Planning Commission Staff Report

Item: Variance Request to Allow a Single-Family Dwelling to Develop a Retaining Wall on Slopes over 30%

Address: 3285 South Sunset Loop Rd

Date: February 3, 2026

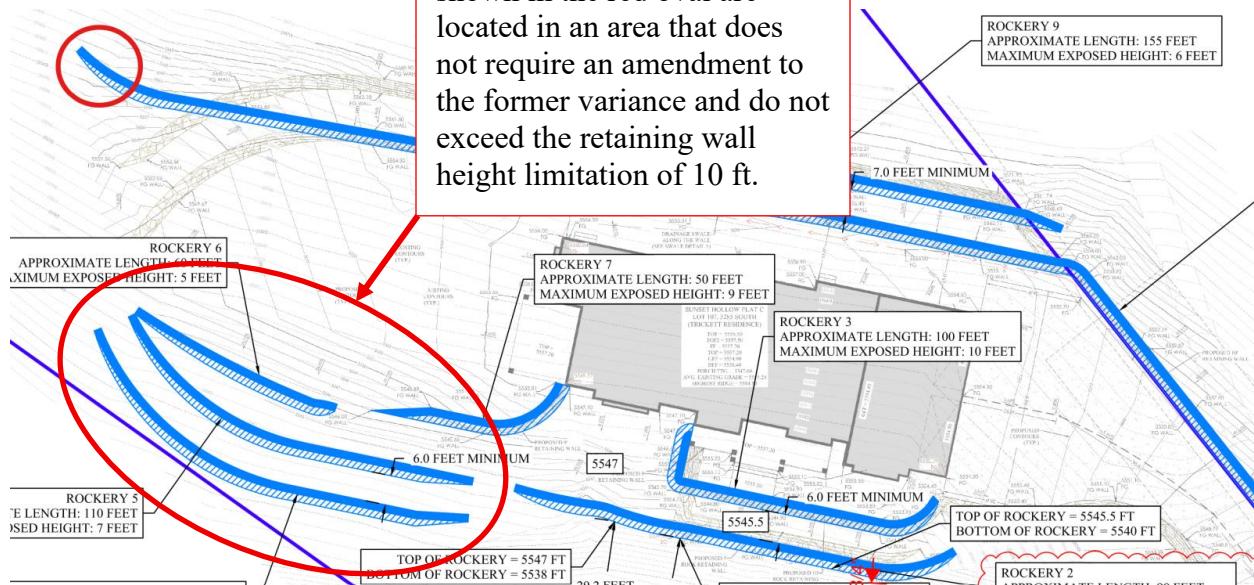
The updated plans show minimal disturbance of the thirty percent (30%) sloped area in two additional areas:

A. The orange area circled in red below shows slopes 30% or greater and has been disturbed with the modified plans.

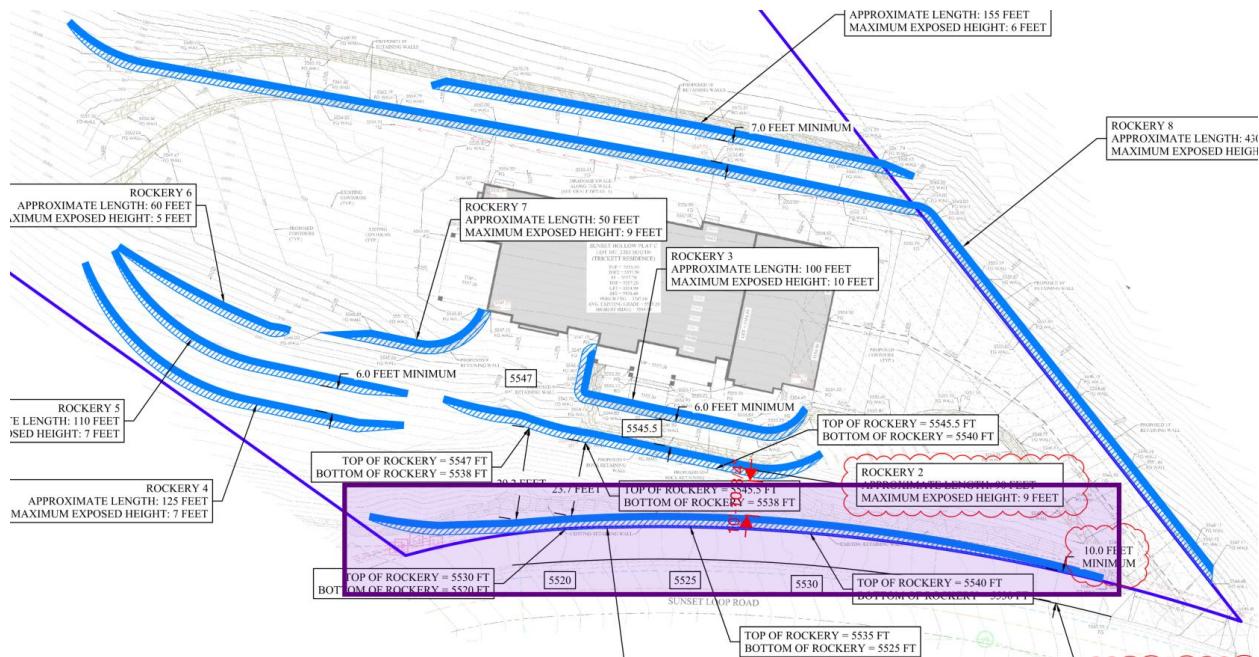
B. The red and orange areas in the purple rectangle indicate slopes 30% or greater, where an existing rock retaining wall is proposed to be replaced with a 10 ft tall rock retaining wall – not changing the level of disturbance from the previously approved site plan.

ROCKERIES
TRICKETT RESIDENCE
3285 SOUTH SUNSET LOOP ROAD
BOUNTIFUL, UTAH
PLAN VIEW

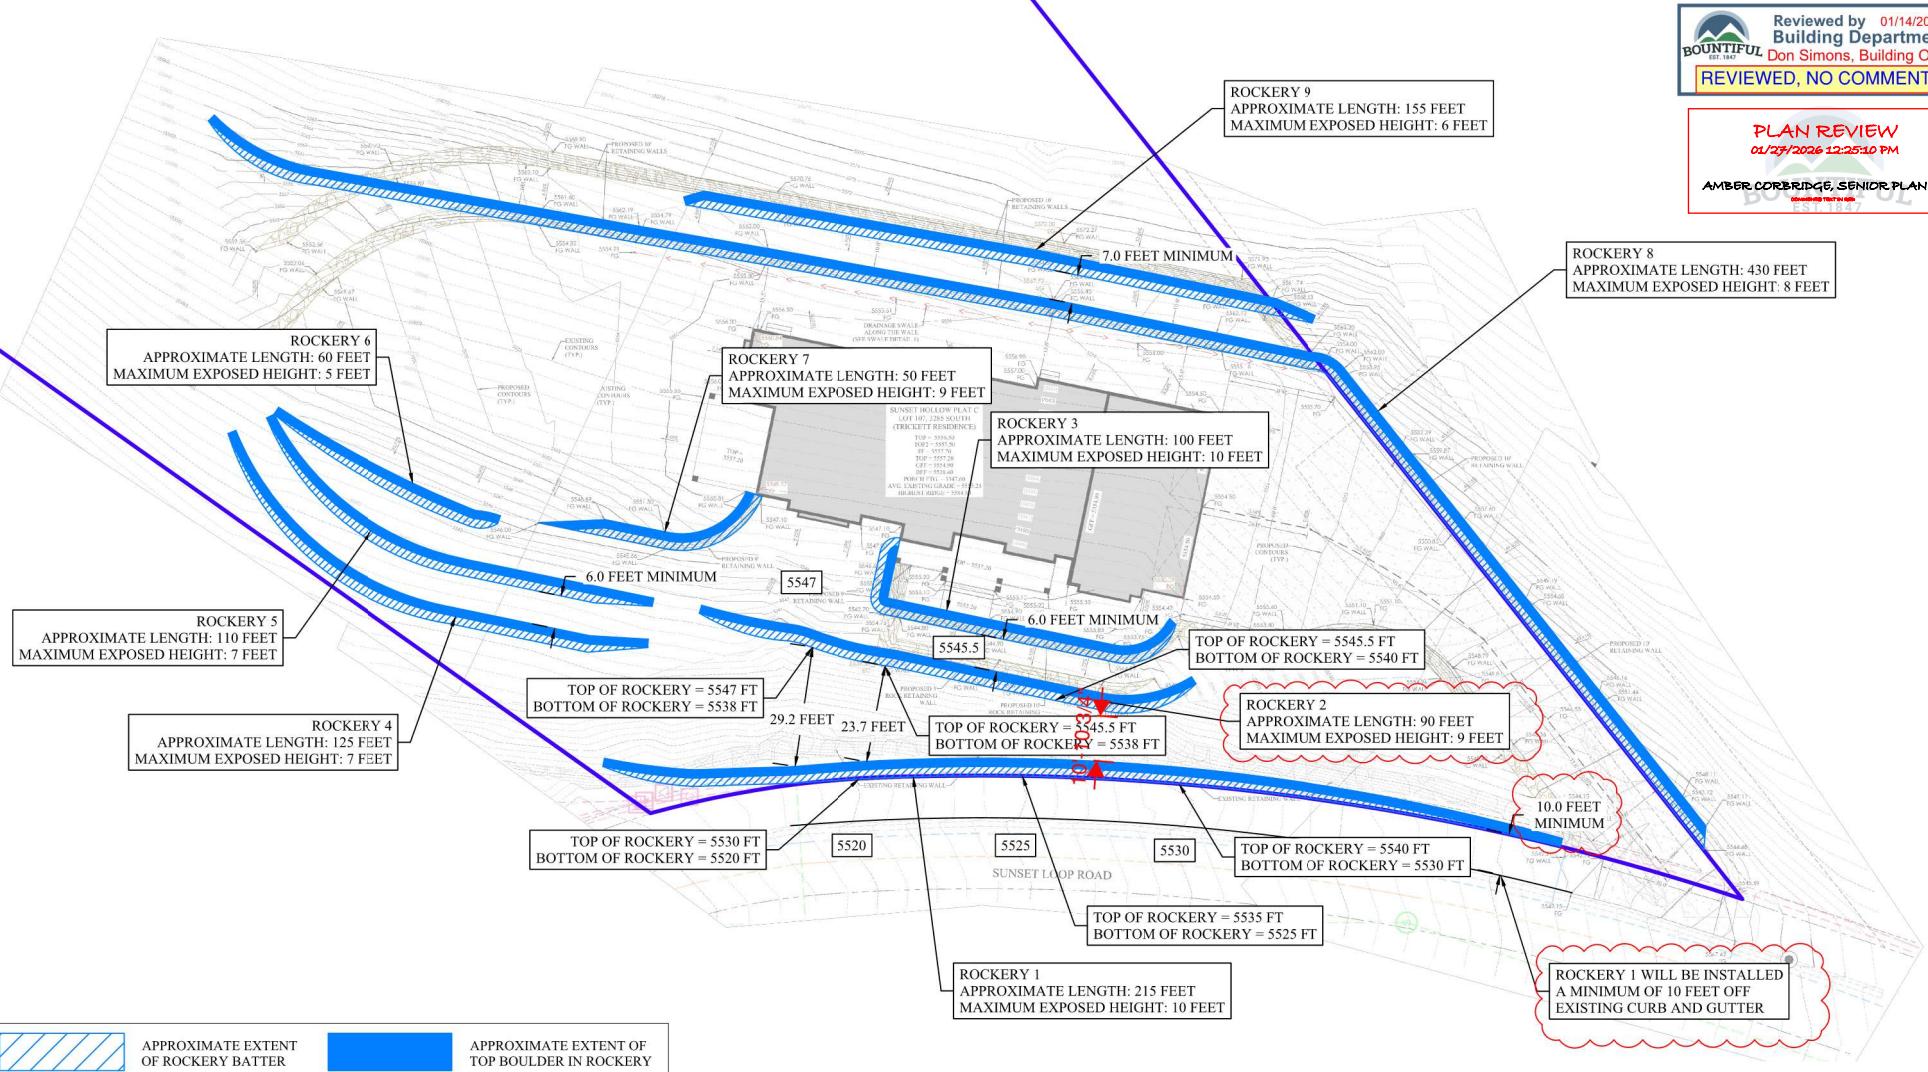
PLAN REVIEW
01/27/2026 12:25:10 PM
